Subject: Final RPM Meeting Notes and Summary July 16, 2008
NAVSTA Newport, Newport Rhode Island

Meeting Notes
RPMs Meeting, July 16, 2008, 3:00 PM
NAVSTA Newport, Newport Rhode Island

GOULD ISLAND DISCUSSION TOPICS

FILE 00949\0210\PROP_SED.DWG	SCALE AS NOTED
FIGURE NUMBER 11-2	REV DATE 0 10/20/07

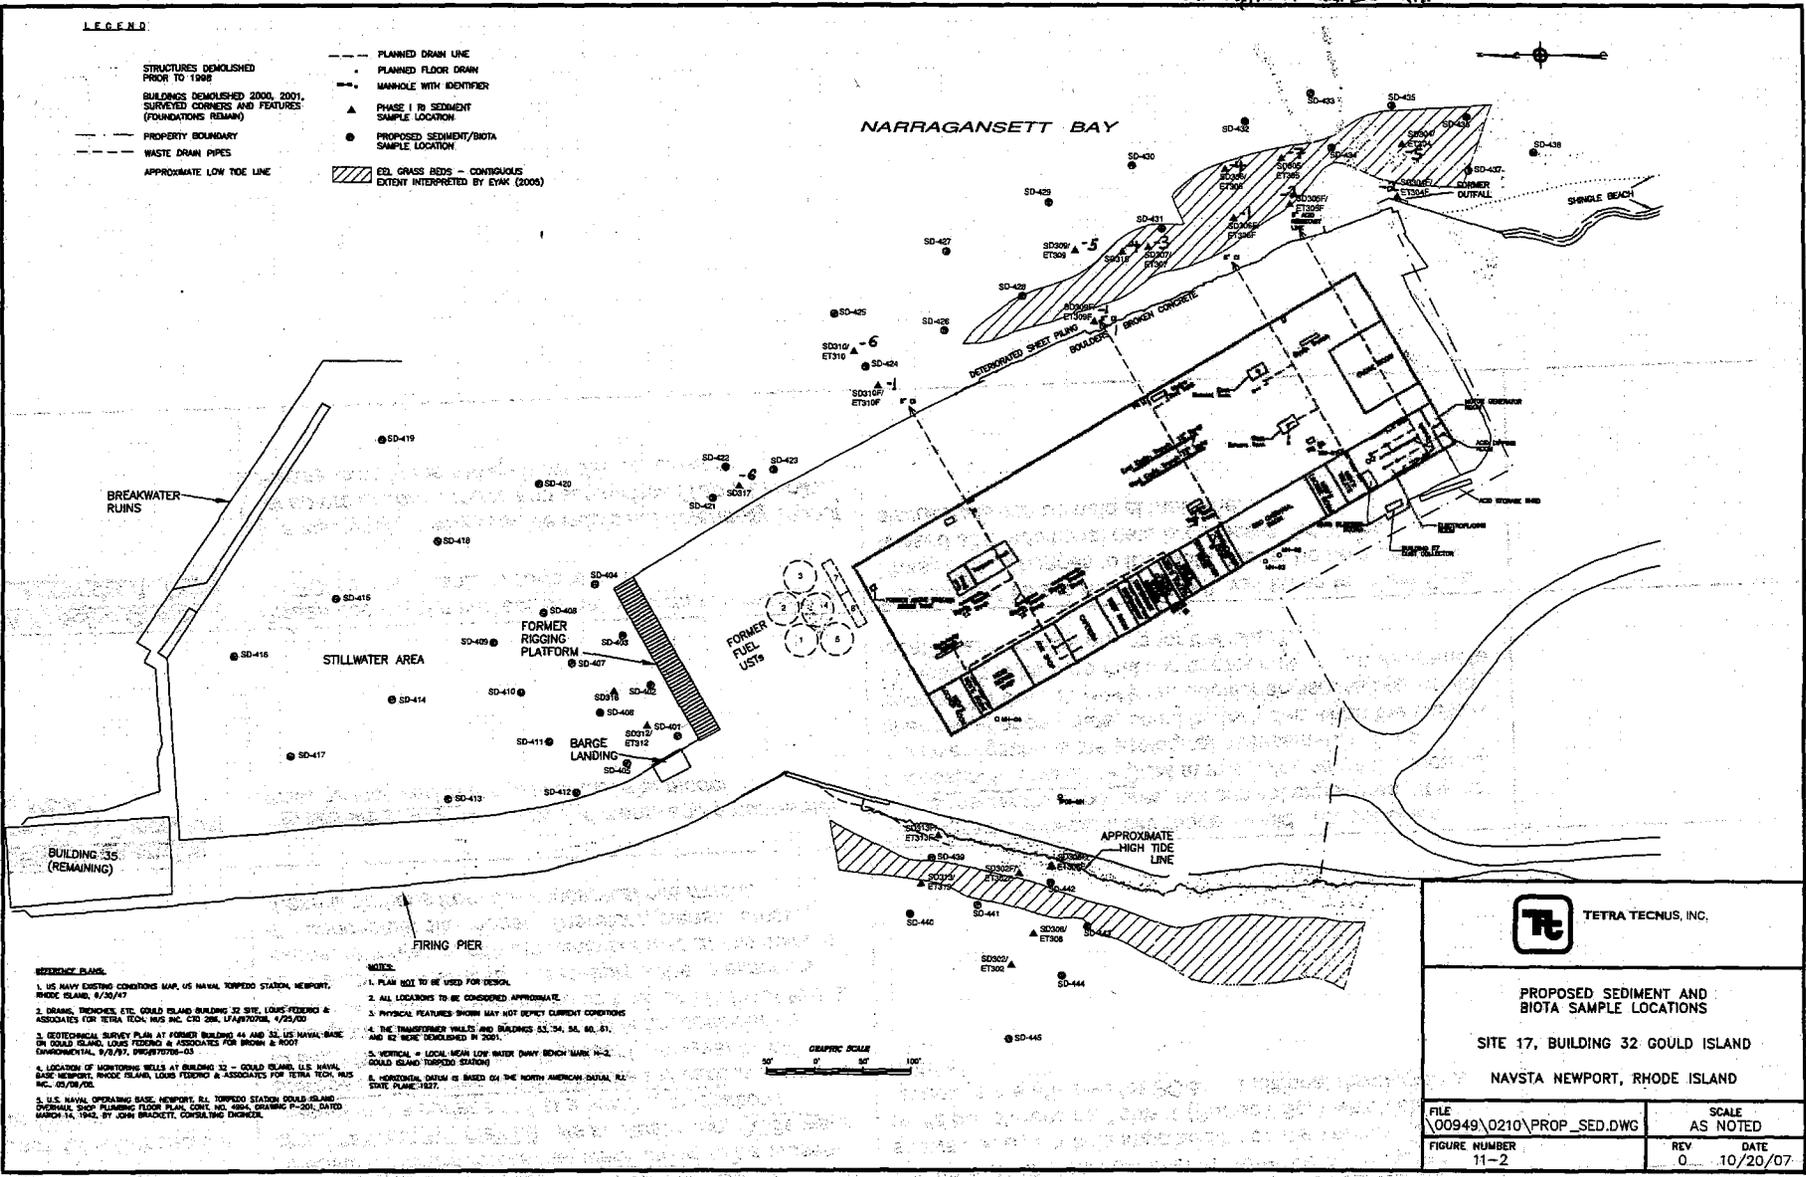
Paul Kulpa requested water depths be provided for the areas where sediment samples would be collected. However, firm bathymetry has not been recorded for this site yet, but a map was marked up with water depths at stations where samples were already collected (provided attached to these notes).
